**23-2336**26 October
2023**TECHNICAL SERVICE BULLETIN****12.3 Inch Instrument Panel Cluster (IPC) Display Screen Without Head Up Display (HUD) - IPC Bezel Misaligned To IPC Display Screen - Built On Or Before 15-Aug-2023****Model:**

Ford 2023 F-Super Duty	Built on or before 15-Aug-2023
----------------------------------	--------------------------------

Figure 1

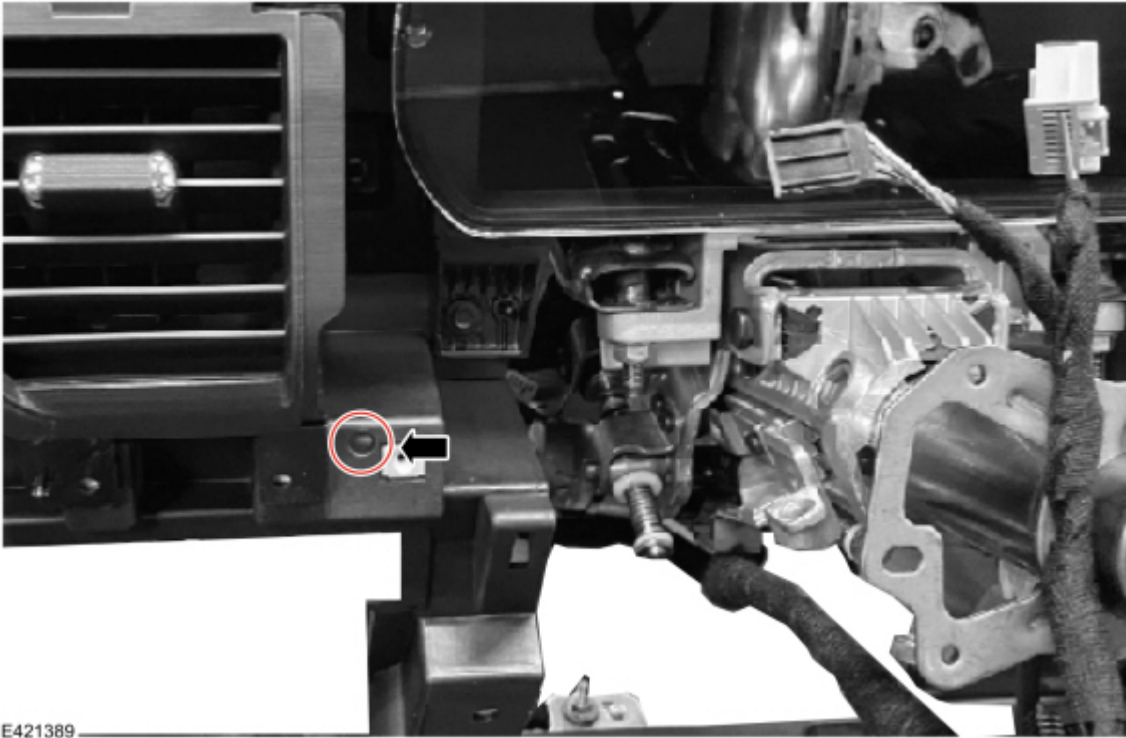
Issue: Some 2023 F-Super Duty vehicles built on or before 15-Aug-2023, equipped with a 12.3 inch IPC display screen and no HUD may exhibit the IPC bezel misaligned to the IPC display screen in lower left corner. This may be due to the locating holes in the instrument panel substrate for the IPC bezel. To correct the condition, follow the Service Procedure to drill out the lower left side locator hole.

2. Drill out the lower left locator hole using a 7/16 in. (11mm) drill bit. (Figure 1)
